**Mount Owen  
Continued Operations Project**  
ENVIRONMENTAL IMPACT STATEMENT

**Response to Submissions**  
REPORT A: NSW Agency and Community Submissions

REPORT A:  
NSW Agency and Community Submissions

Project Director: **Barbara Crossley**  
Project Manager: **David Holmes**  
Report No. **3109/R16/V4**  
Date: **June 2015**

FIGURE 4.11

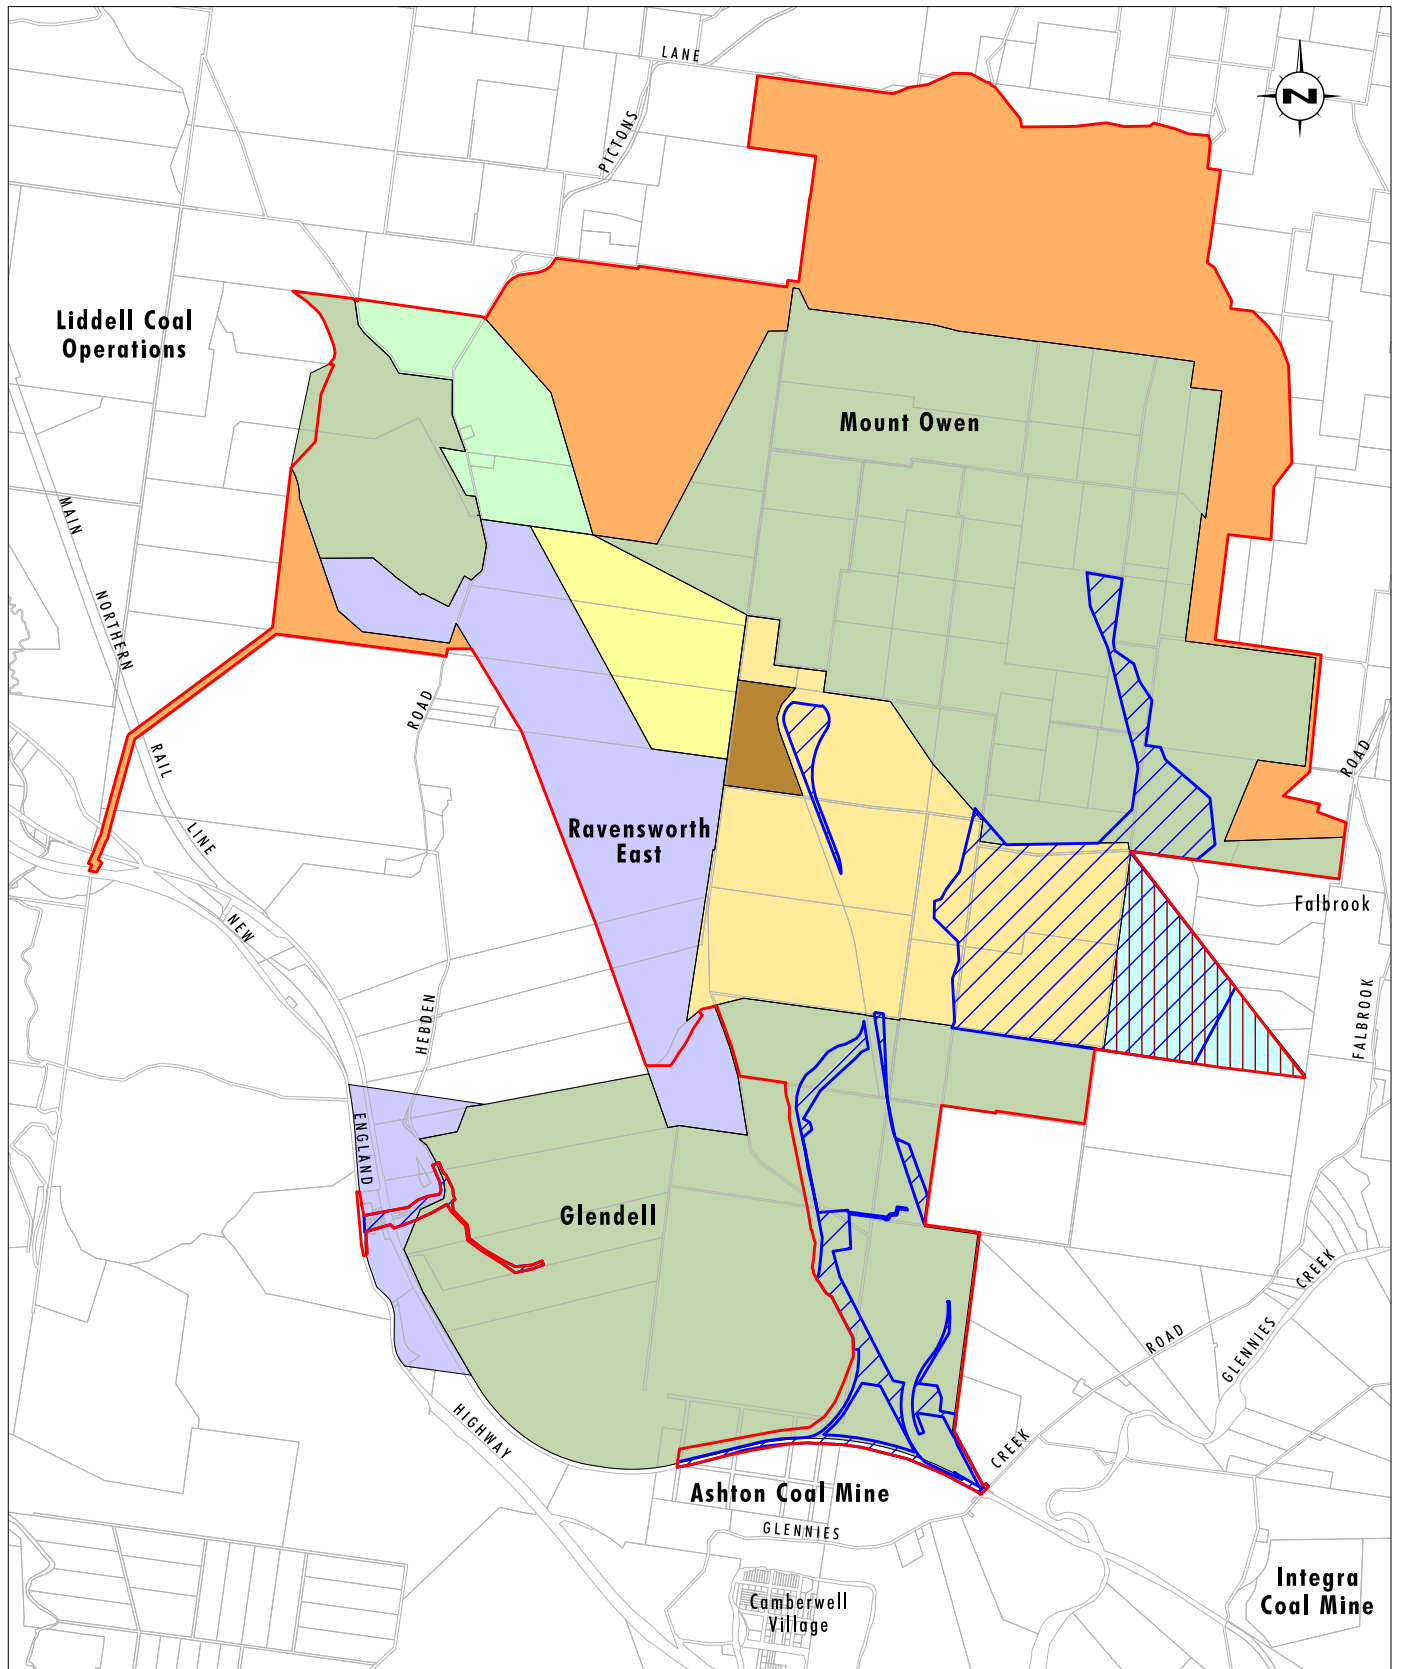
***As coal is a prescribed mineral under the Mining Act 1992, the proponent is required to hold appropriate mining titles from the Division in order to mine this mineral. The Division understands the proposed mining activities are within existing mining titles held by the Proponent.***

All mining activities will be undertaken within areas covered by existing mining titles held by the Proponent. A review of the mining titles for Mount Owen show that an area of the proposed North Pit Continuation is located in an area where there are no mining leases applying to the land between the surface and a depth of 15.24 metres. We note however that the surface to 15.24 metres in this area is subject to Assessment Lease 8 (AL08) with mining leases CL382 and ML1415 applying to all strata below a depth of 15.24 metres. **Figure 4.11** shows the coverage of the various leases which apply to the Project Disturbance Area. An application to convert AL08 to a Mining Lease will be made by Mount Owen and mining and mining purposes associated with the Project will not commence in this area until a lease is granted over the area.

**Figure 2: Frequency of occurrence of PM<sub>10</sub> concentrations at Jerrys Plains, Merriwa and Wybong**

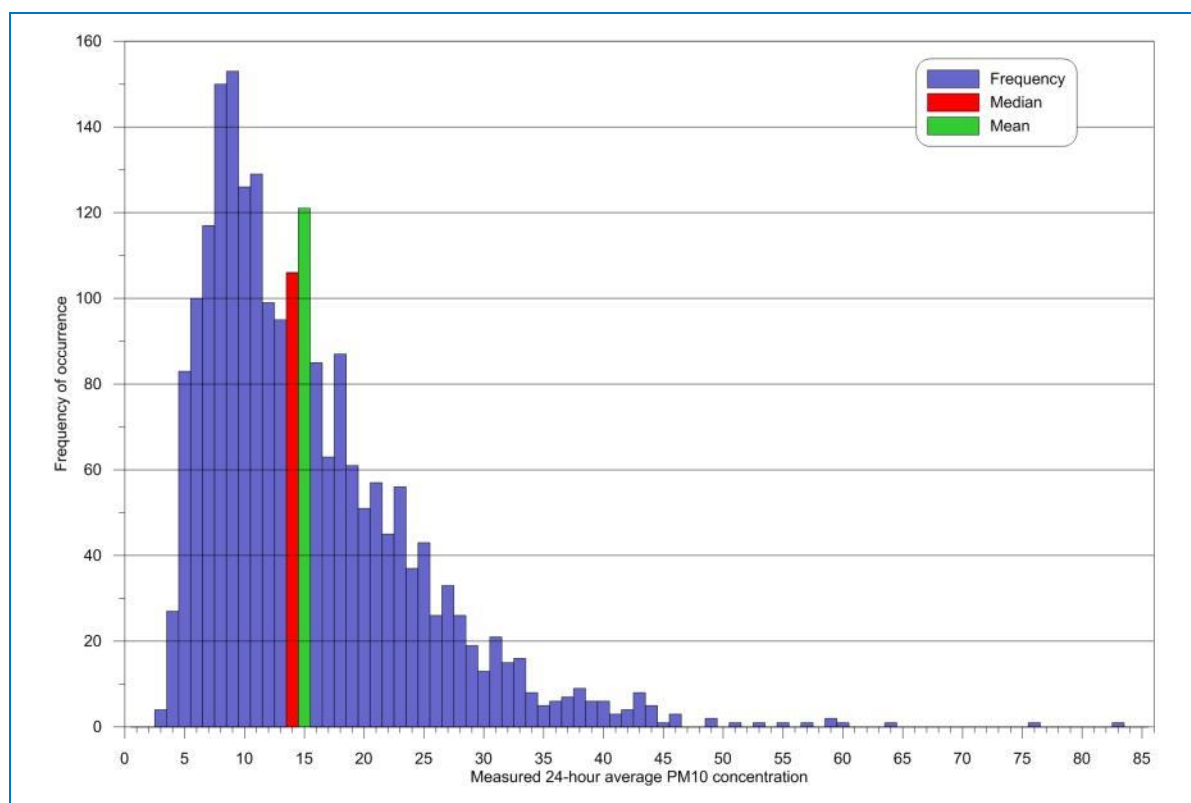
There was also a comment from the EPA relating to the way this value was determined and the potential reduction of the influence of extreme values. It is not explicit from the comment, but we assume this refers to the use of the median value rather than the annual mean (described in Section 5.3.2 in the AQIA). The median value was used to reduce the influence of significant weather events which are unpredictable into the future and can potentially skew the annual mean. **Figure 2** shows the frequency of occurrence of the 2,148 measured values from the Jerrys Plains, Merriwa and Wybong UHAQMN monitoring sites in ranges of 1 µg/m<sup>3</sup>. The median and mean values are shown in red and green, respectively.

As can be seen from **Figure 2**, there is a strong skew in the data with a higher frequency of occurrence of lower measured PM<sub>10</sub> concentrations. The histogram shows that the mean is slightly affected by the relatively few higher measurements, particularly those above the annual criterion of 30 µg/m<sup>3</sup>. Given that the median is closer in value to the most frequently observed concentration levels shown in the data, its use as the basis for the background levels in the cumulative PM<sub>10</sub> annual average assessment is considered to be appropriate.

**Figure 6: Monitoring sites, source locations for existing mines and calibration grid**

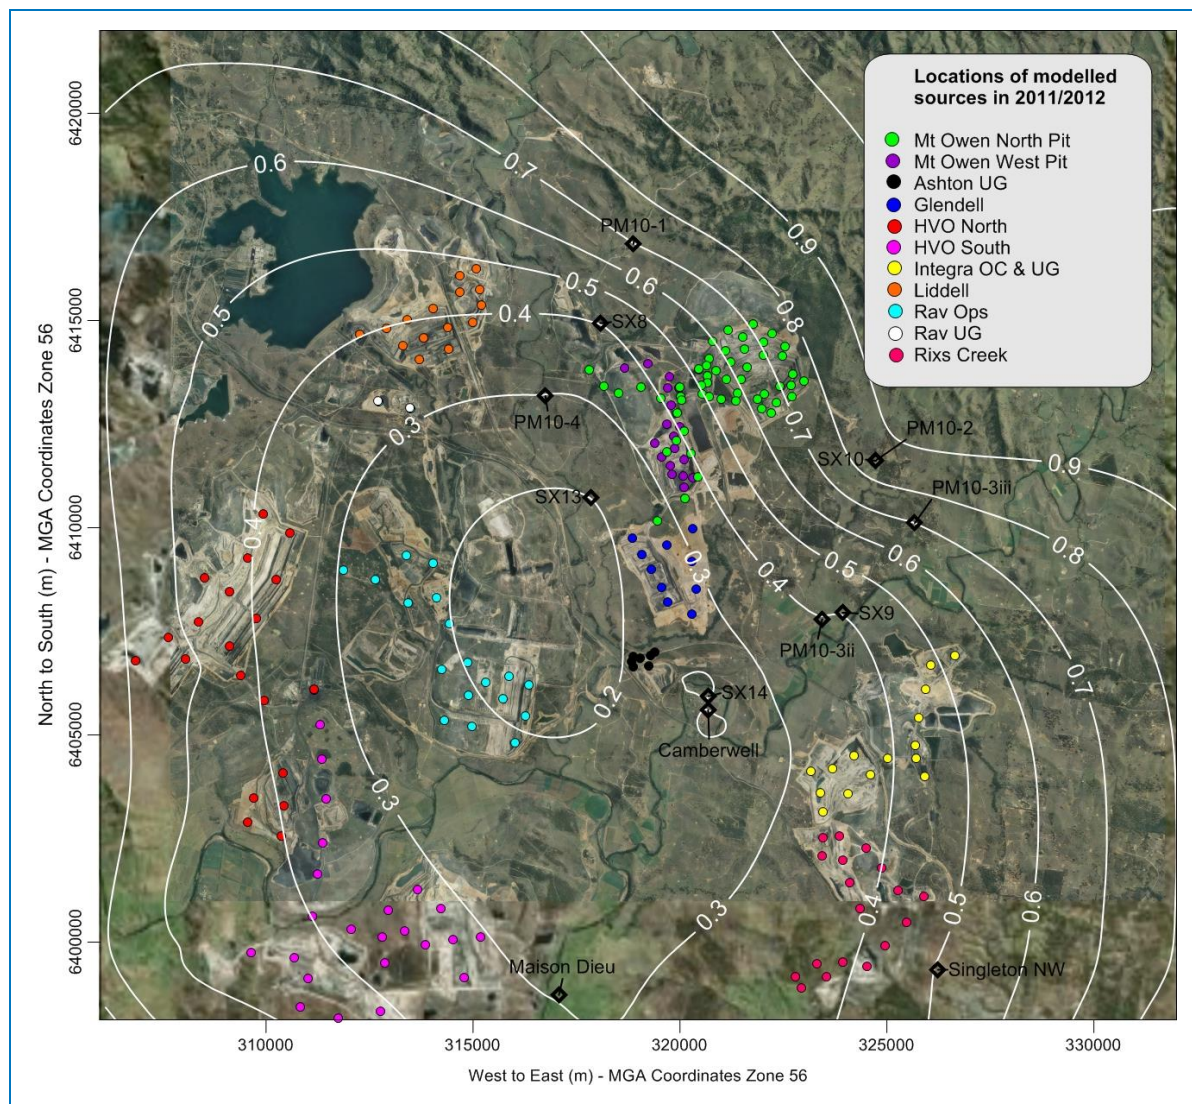
The calibration issue was discussed in detail in the meeting with the EPA and DP&E (28 May 2015). While the EPA and DP&E were generally supportive of the approach to further improve the accuracy of modelling, the following issues or areas of concern were raised in relation to the calibration approach used in the AQIA:

- The model performance was lower and was significantly over predicting concentrations in areas where other mines were the dominant source. The question was raised as to whether the model inputs were based on actual production or were derived from predictions in publically available assessment documentation.

- As noted in the EPA submission, there are areas of the model which have a calibration factor of 0.2 and modelling predictions of the contributions from other mining sources would be multiplied by 0.2 (divided by 5) in these areas. There was a concern that this level of calibration may remove the conservativeness in the modelled predictions, particularly given Camberwell Village was in an area with this 'higher' level of calibration.

It is important to understand that this calibration grid is only applied to the 'other mines' model output in the modelling of cumulative impacts for years 1, 5 and 10 off the Project. That is, the calibration is not applied to the Project, nor to the estimated 'background'. In other words, the following 'equation' is assumed:

It is clear from **Figure 7** that the model performs much better close to the existing Mount Owen operations, where significantly more detail was available for modelling. It also performs well in the Middle Falbrook area where there are a significant number of residential properties, which means there is less model adjustment required in those areas.

Figure 7: Predicted cumulative annual average PM<sub>2.5</sub> concentrations in Year 1 (µg/m<sup>3</sup>)

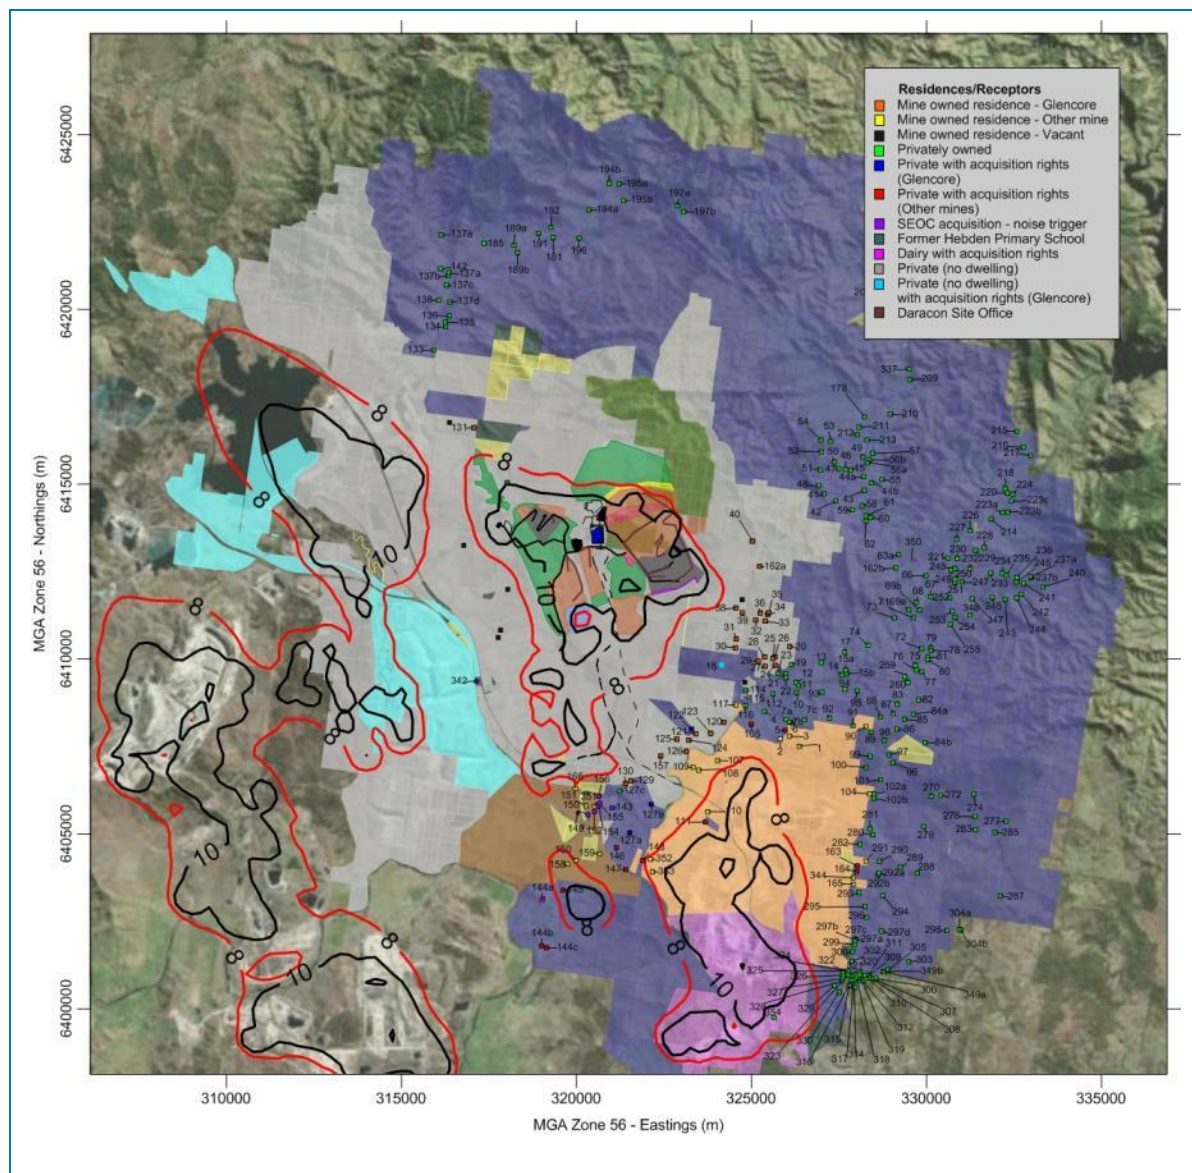
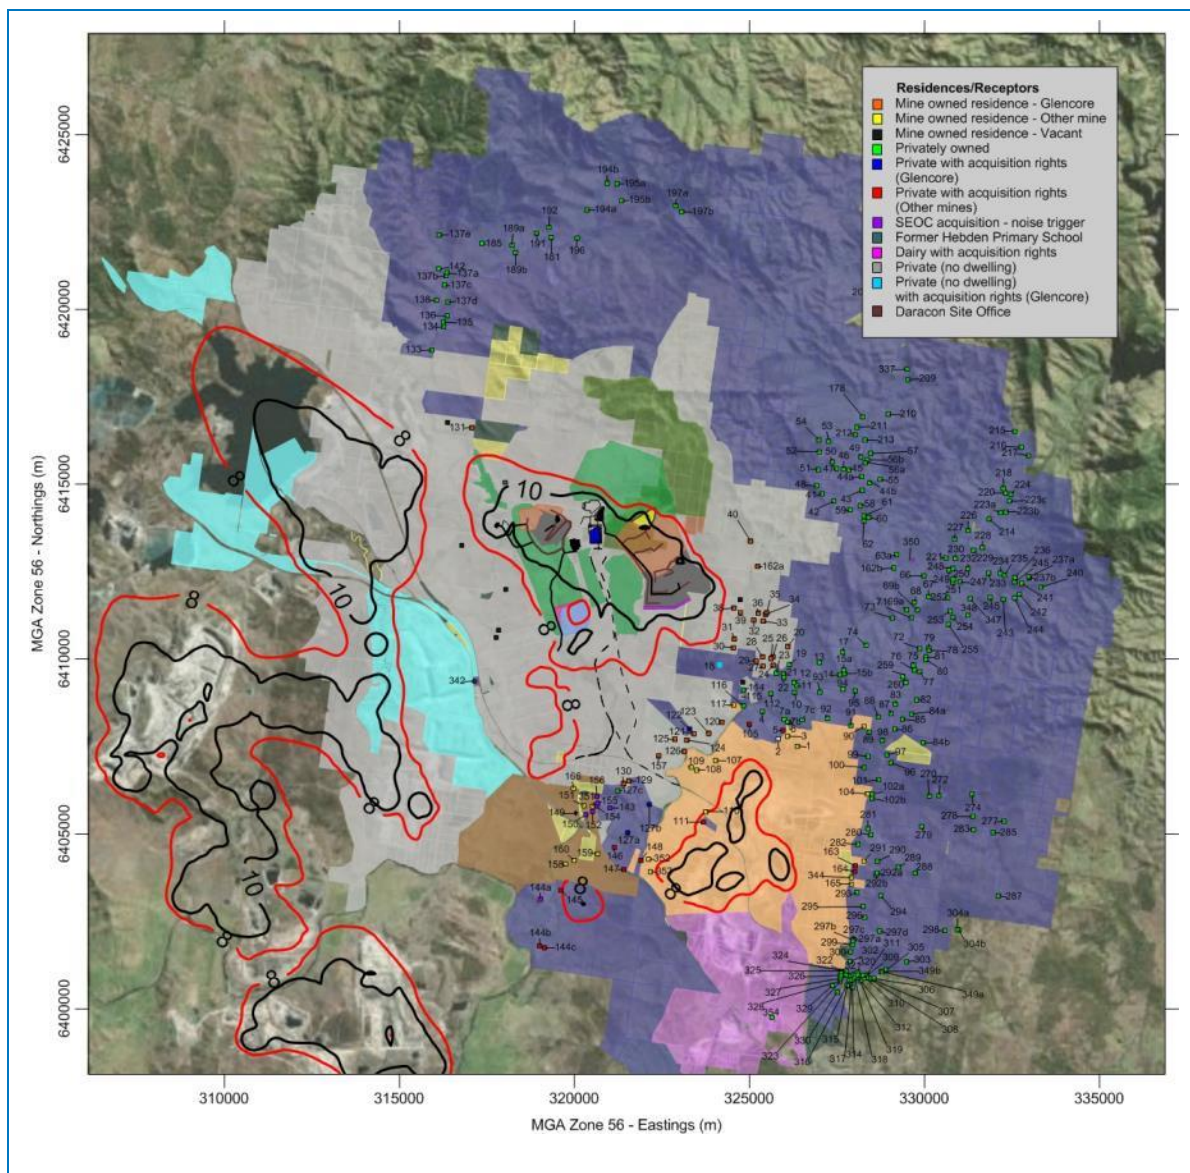
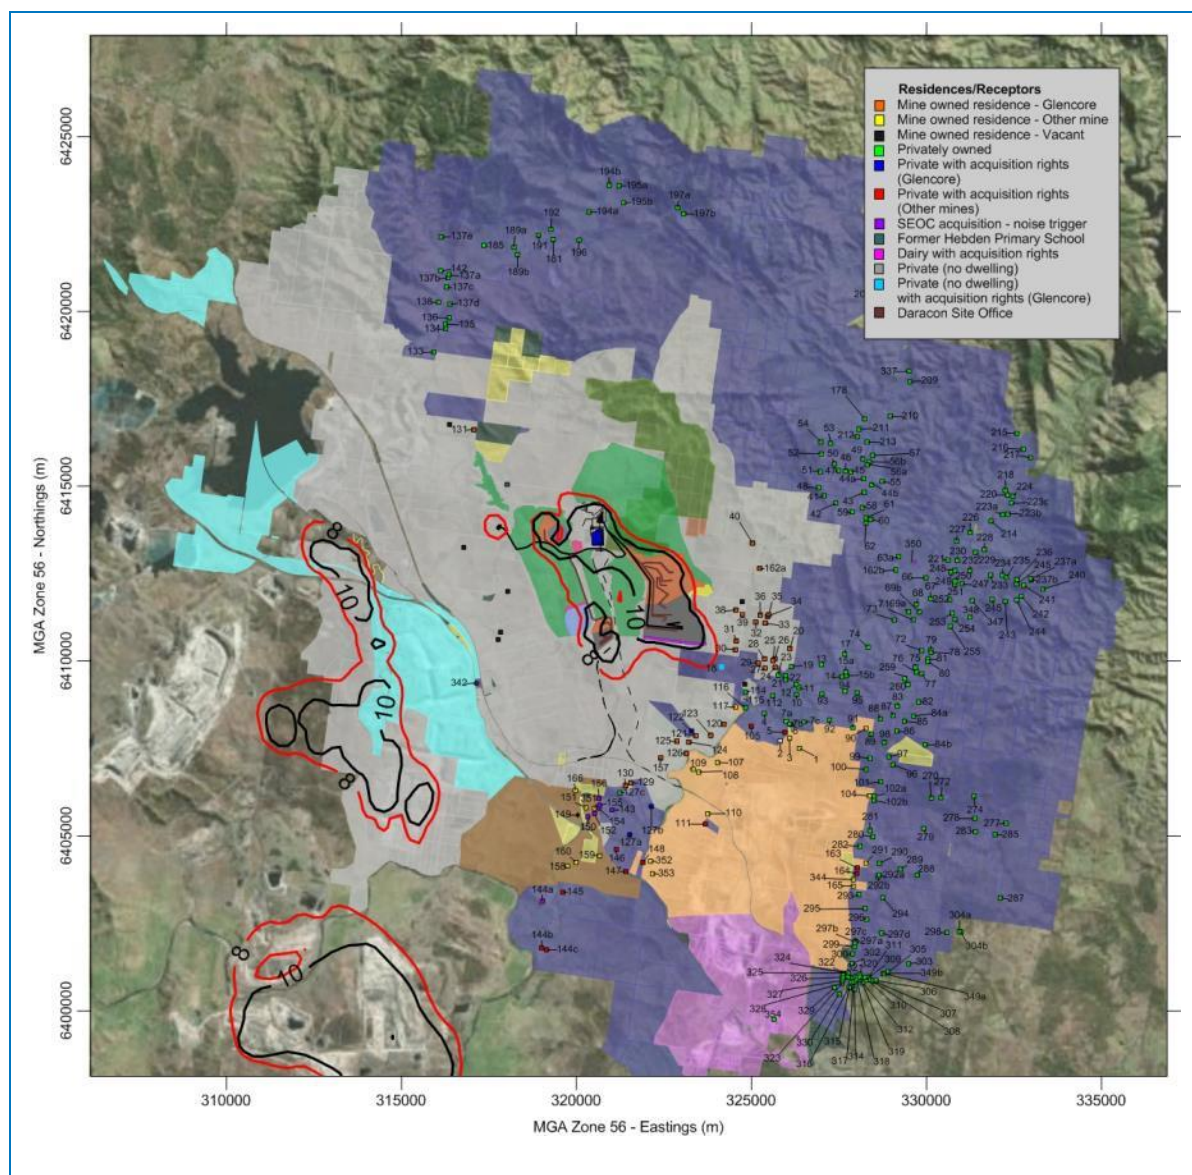
*Figure 10.20 'Predicted annual average PM<sub>2.5</sub> concentrations in Year 1 – Cumulative', on page 103, of Appendix 6 - Air Quality Assessment, identifies that many properties will be subject to annual average PM<sub>2.5</sub> levels above the proposed NEPM standard of 8 µg/m<sup>3</sup> however, the modelling suggests most of this impact will come from existing mines. Figure 10.21 'Predicted annual average PM<sub>10</sub> concentrations in Year 1 – Cumulative', page 104, identifies that many private residences will be subject to annual average PM<sub>10</sub> levels above 20 µg/m<sup>3</sup>. In excess of 30 residences in Wattle Ponds and to the north of Wattle Ponds (not mine owned or subject to acquisition will experience annual PM<sub>10</sub> levels above 20 µg/m<sup>3</sup>.*

Using this updated estimation of 'background' PM<sub>2.5</sub> (i.e. 5.3 µg/m<sup>3</sup>), the annual cumulative concentrations have been recalculated and the updated plots for Years 1, 5 and 10 are presented in **Figure 7, 8 and 9**, respectively.

Table 4 lists the residences that are predicted to exceed the annual average ARS of 8 µg/m<sup>3</sup> using the background levels of 5.3 µg/m<sup>3</sup>. There are no predicted exceedances in Year 10.
